Office Action Summary

10/596,829

SCHMIDT ET AL.

DETAILED ACTION

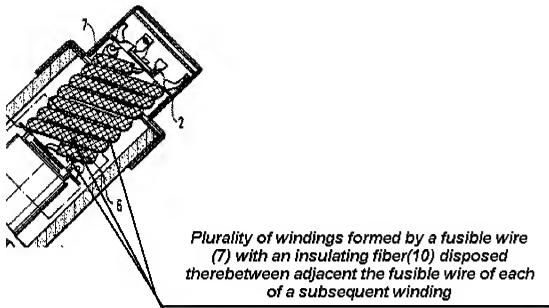
5. Claim 12, as best understood, is rejected under 35 U.S.C. 102(b) as being anticipated by US/4,523,172 to Drothen et al. (Drothen).

Regarding claim 12, as best understood, Drothen disclosed (Fig. 2-3) a fusible conductor for a fuse element, said fusible conductor comprising: an electrically insulating core (6); a fusible wire (7) wound about and in contact (at least thermal) with the core (6) forming as a plurality of

first windings; and an electrically insulating fiber (10, 11) wound about the core forming a plurality of the second windings and disposed between each of said plurality of the first windings such that the insulating fiber is adjacent a fusible wire of a subsequent winding (see annotated figure below):

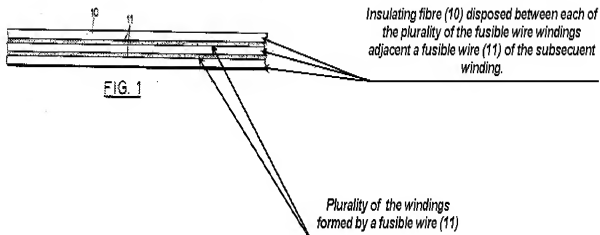
6. Alternatively, claim 12, as best understood, is rejected under 35 U.S.C. 102(b) as being anticipated by US/ 3,486,155 to MCCAUGHNA.

Regarding claim 12, MCCAUGHNA disclosed (Fig. 1, 2) disclosed (Fig. 2-3) a fusible conductor for a fuse element, said fusible conductor comprising: an electrically insulating core (12); a fusible wire (11) wound about and in contact (at least thermal) with the core (12) forming a plurality of first windings; and an electrically insulating fiber (10) wound about the core forming a plurality of second windings and disposed between each of said plurality of the first

windings such that the insulating fiber of each of the second winding is adjacent a surface of the fusible wire of a subsequent one of the first windings (see annotated figure below):
